**Town of Trumbull
CONNECTICUT**

**PLANNING AND ZONING
COMMISSION**

To: MEMBERS OF THE PLANNING AND ZONING COMMISSION
RE: REGULAR MEETING – **WEDNESDAY, DECEMBER 15, 2021**

2. **55 Merritt Blvd**: Applicant, Levco Mechanical Group, is requesting a Special Permit/Site Plan to (1) install 4 storage containers and security fence to allow storage of propane cylinders and associated safety supplies and equipment; (2) installation of 2,500 gallon storage/dispensing tank for filling propane tanks and (3) installation of 3,000 gallon diesel fuel storage and dispensing tank to fuel the Levco trucks in an I-L3 Zone pursuant to Art. II, Sec. 4.3 and Art. XV of the Town of Trumbull Zoning Regulations. **File #21-26**

Drawing No.	C100
-------------	------

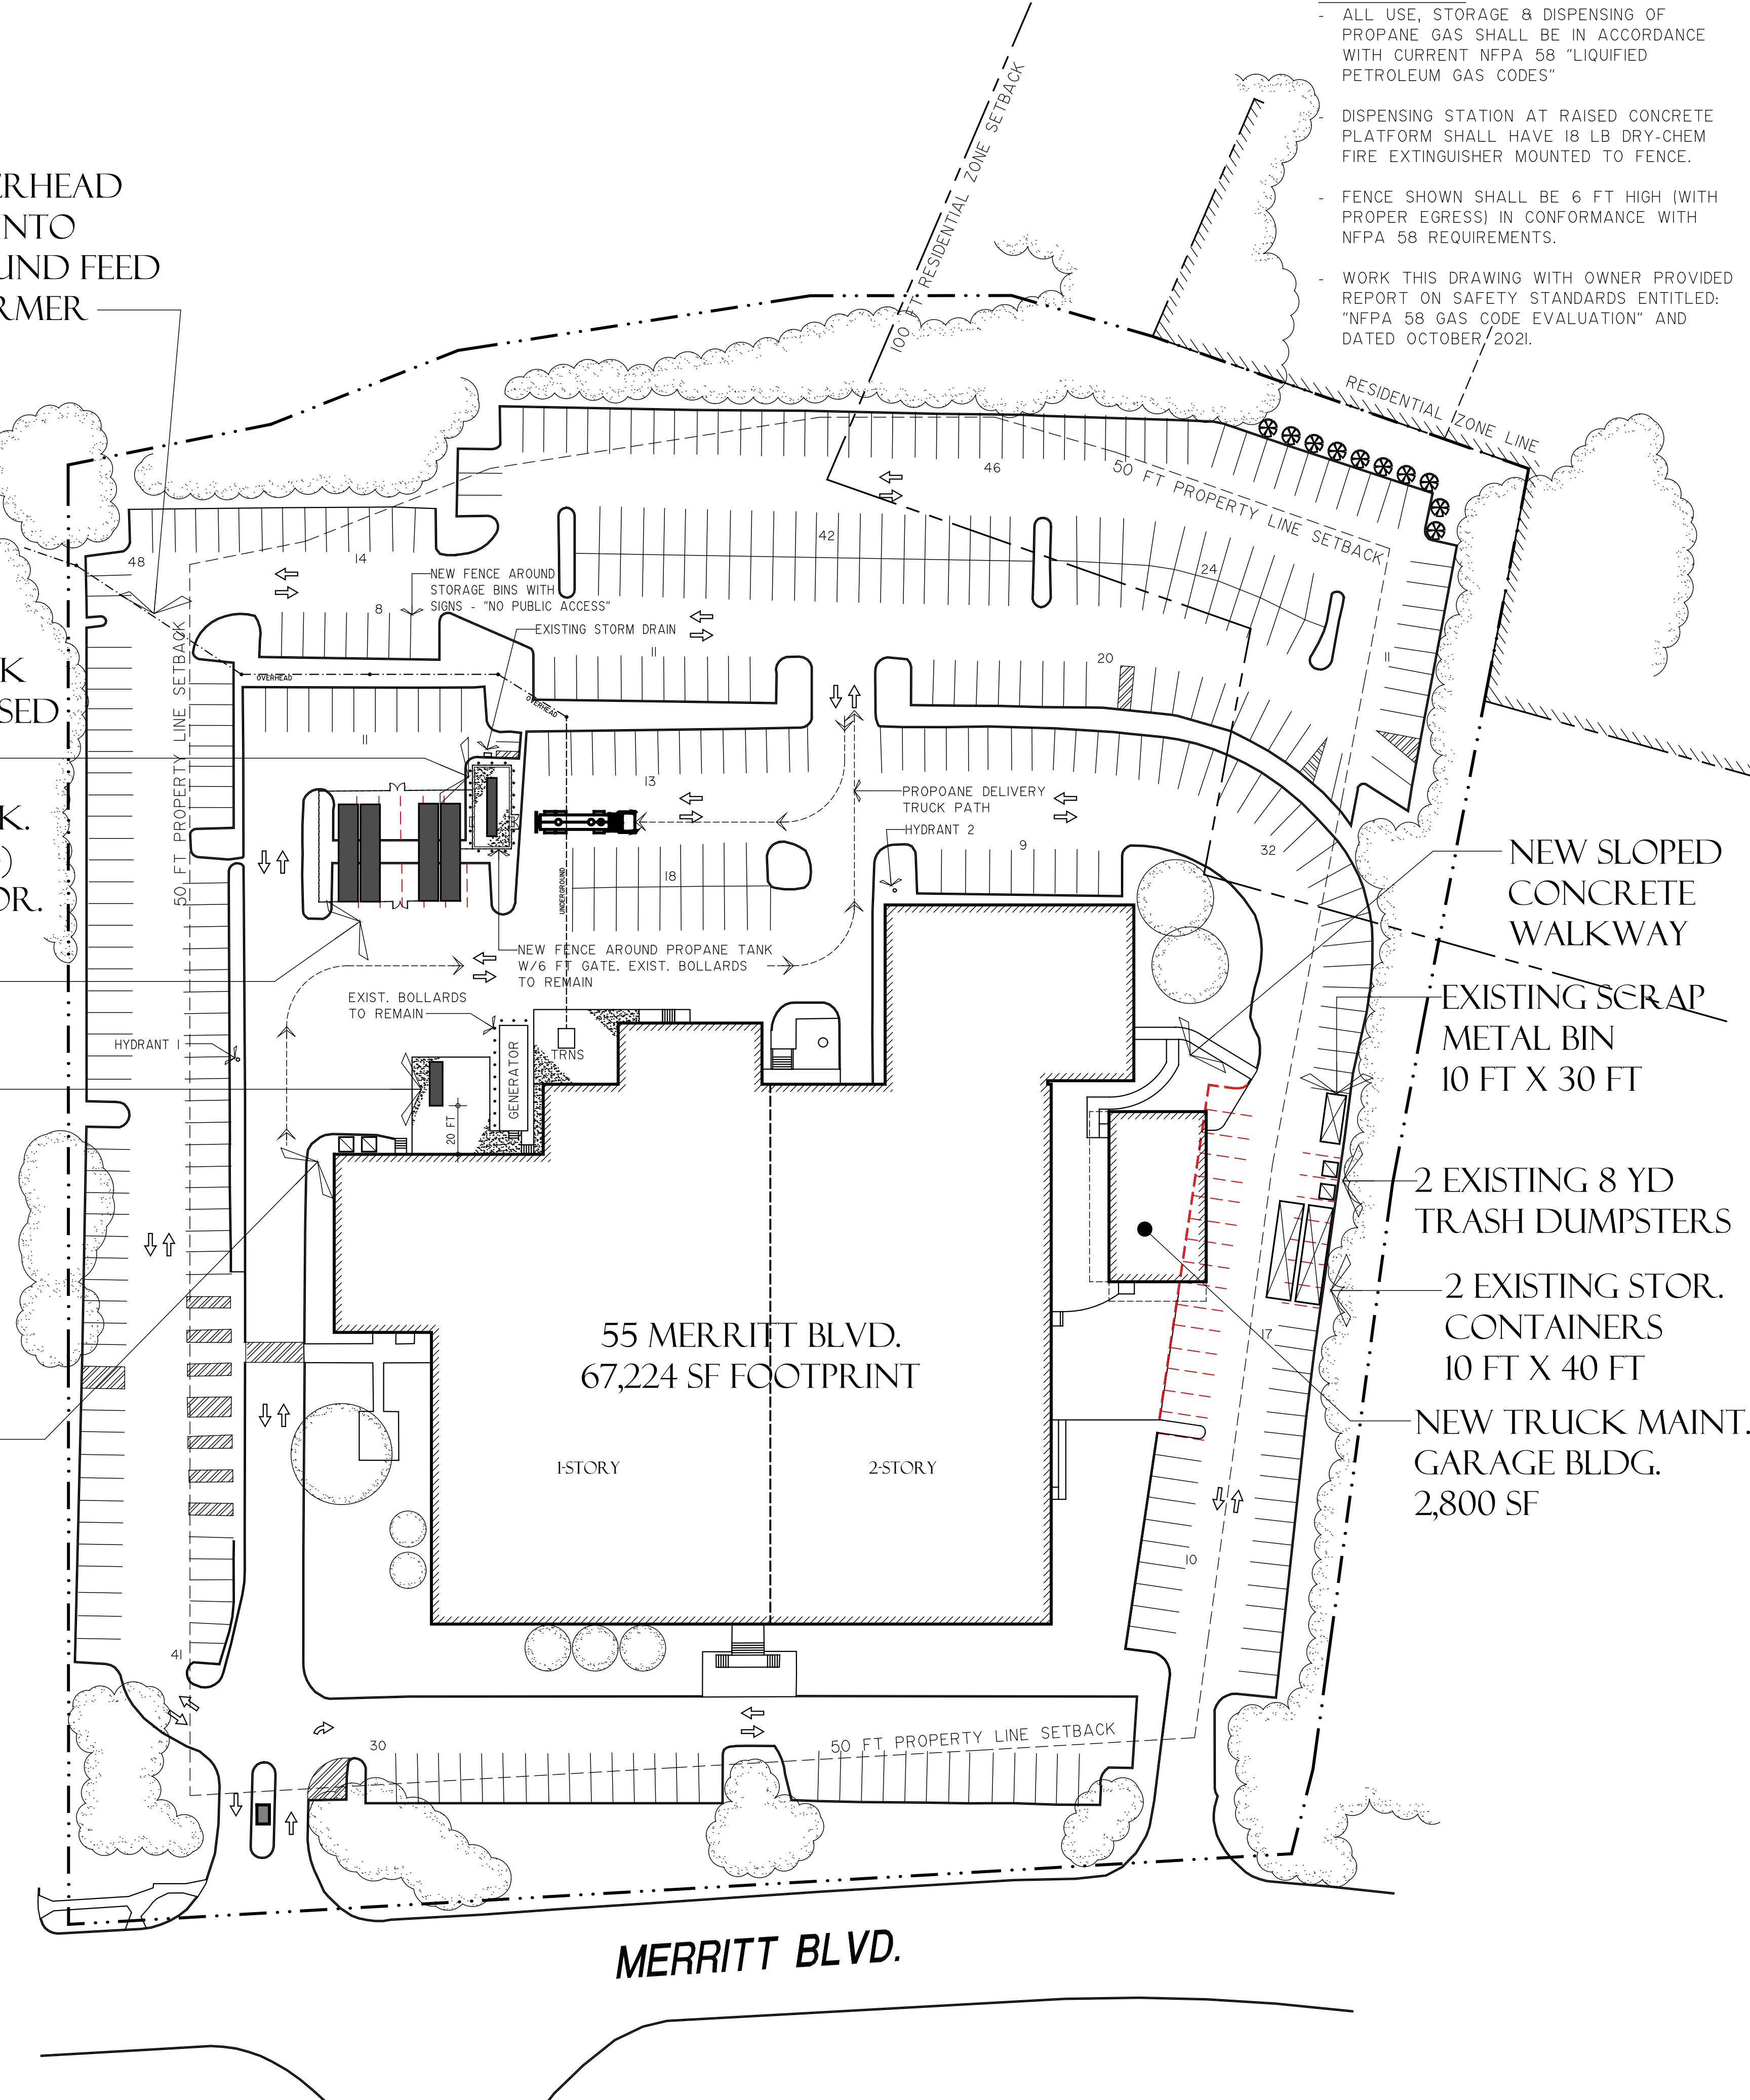
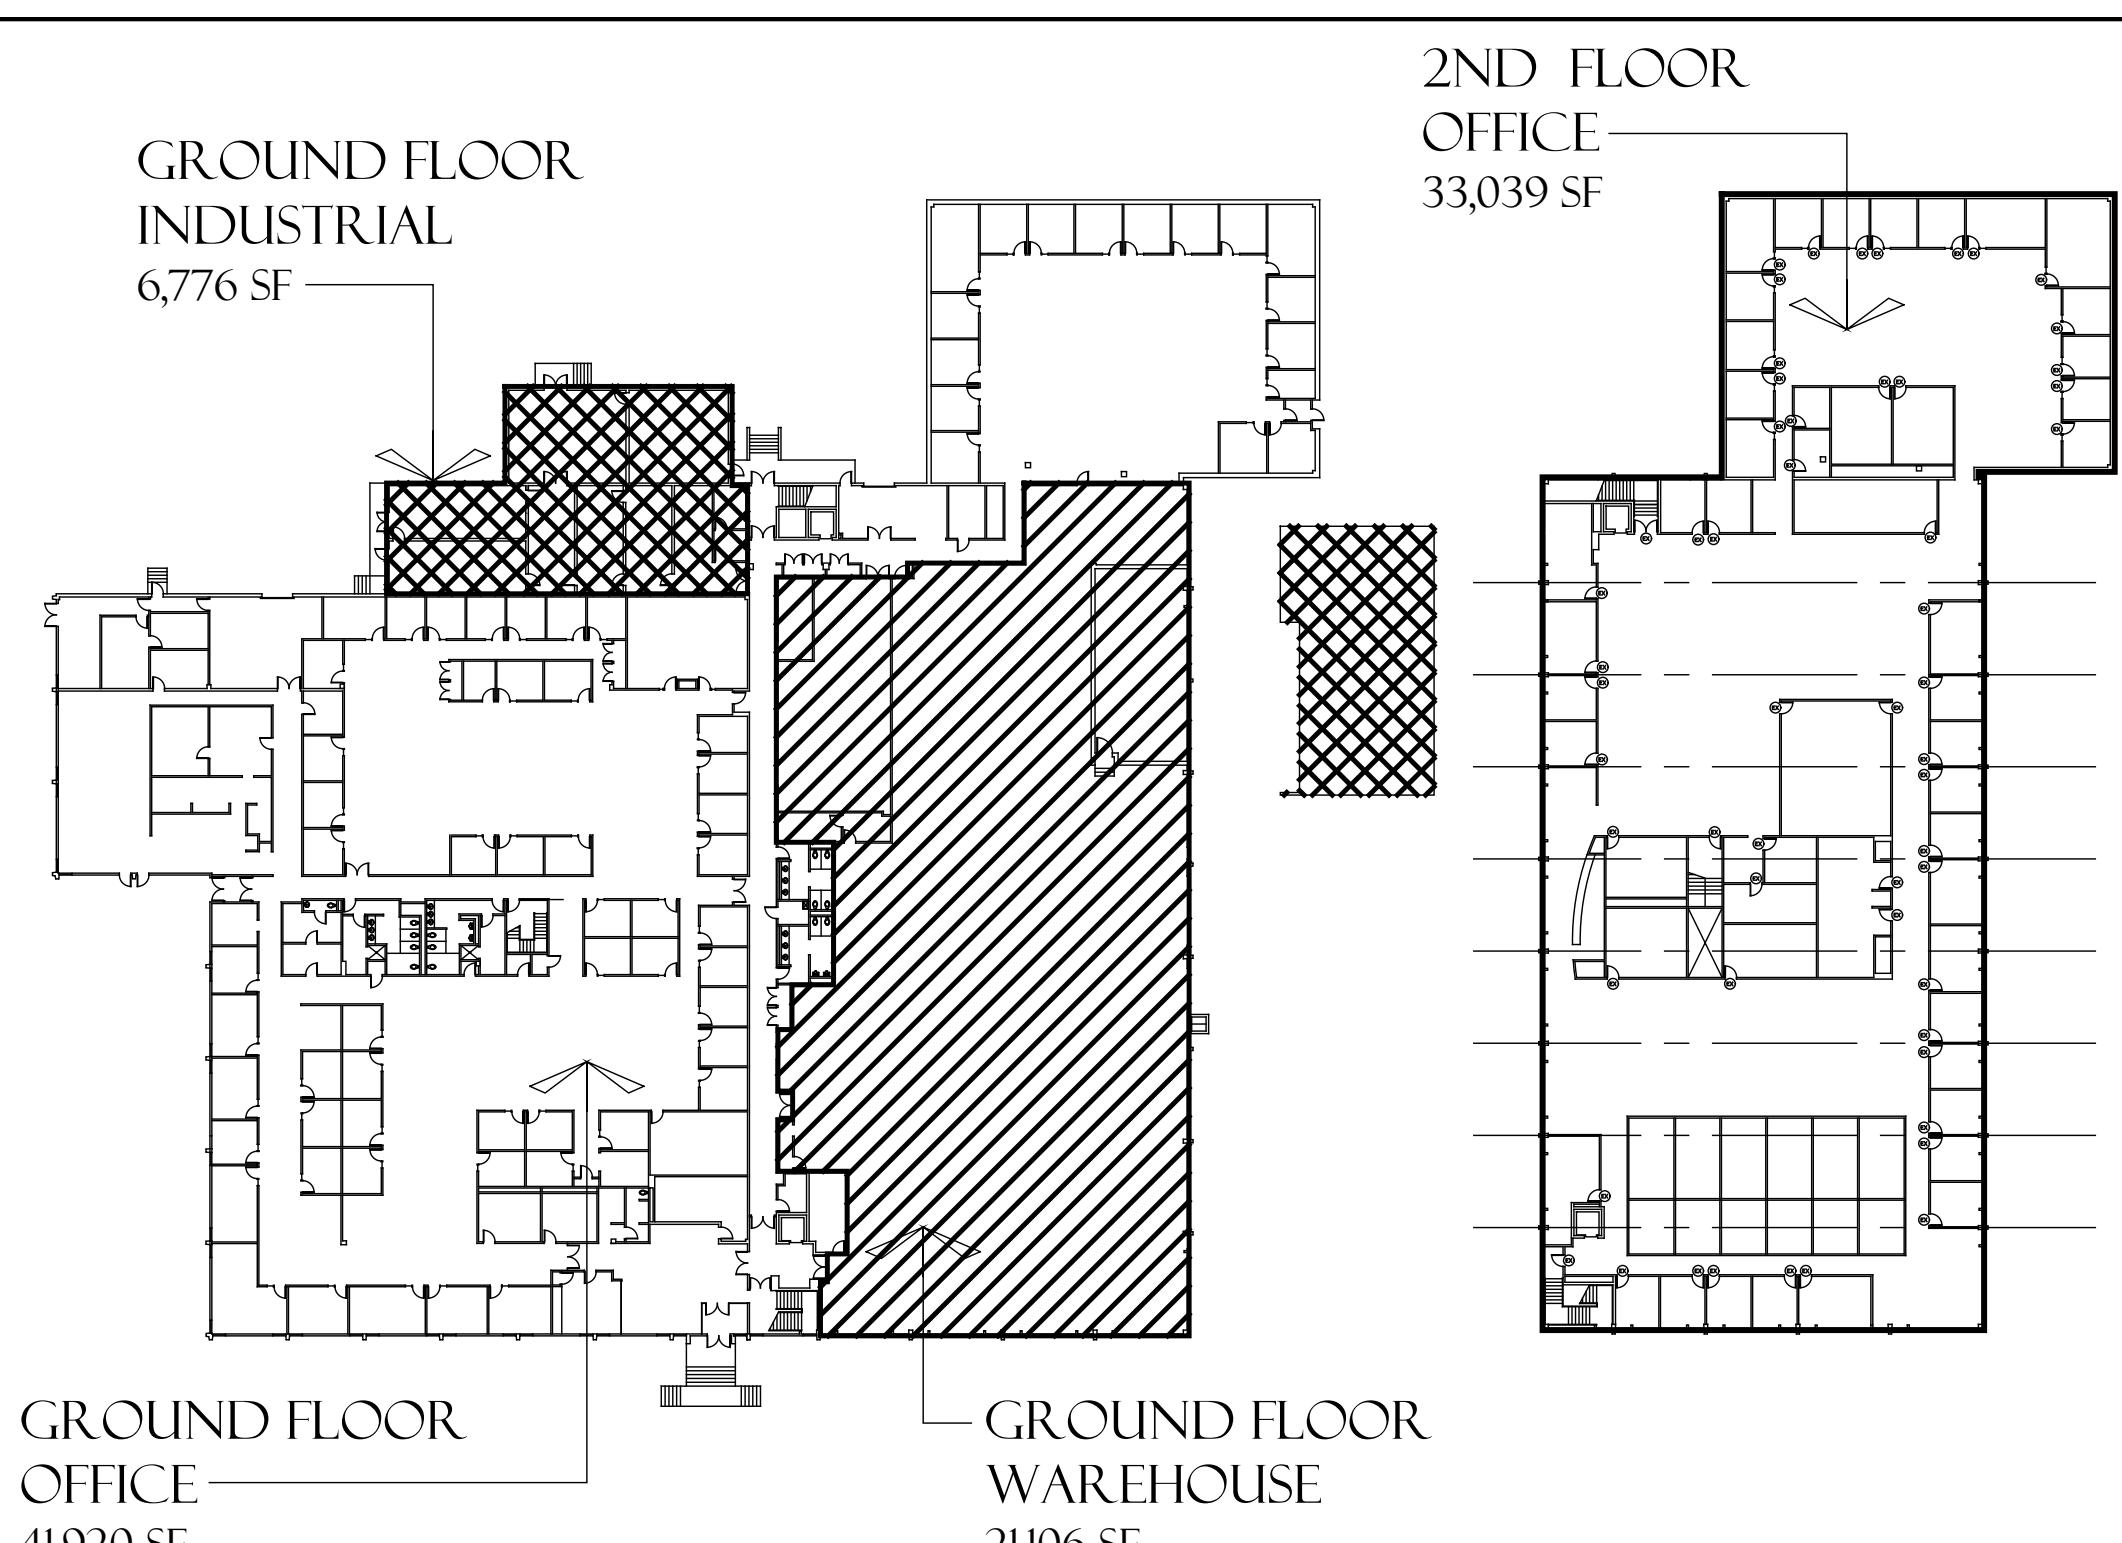
4. Will the fuel truck be stored onsite? If so please label on the plan. Can they fit in one parking space? Is there distance requirements between each truck?

15. Do the existing storage containers need to be located in the driveway can they be moved to the rear of the building? as not to obstruct more useable parking spaces than those in the rear?

I will be on the call to answer questions. At present there isn't enough space for two lanes. These are temporary storage containers that will be removed when all construction is completed and may be moved during construction at which time there will be two lanes for traffic.

We will start with two propane bobtail trucks and a pickup truck for delivery and add more equipment as business allows.

These temporary storage containers are being used during construction and will be removed when all construction is completed.
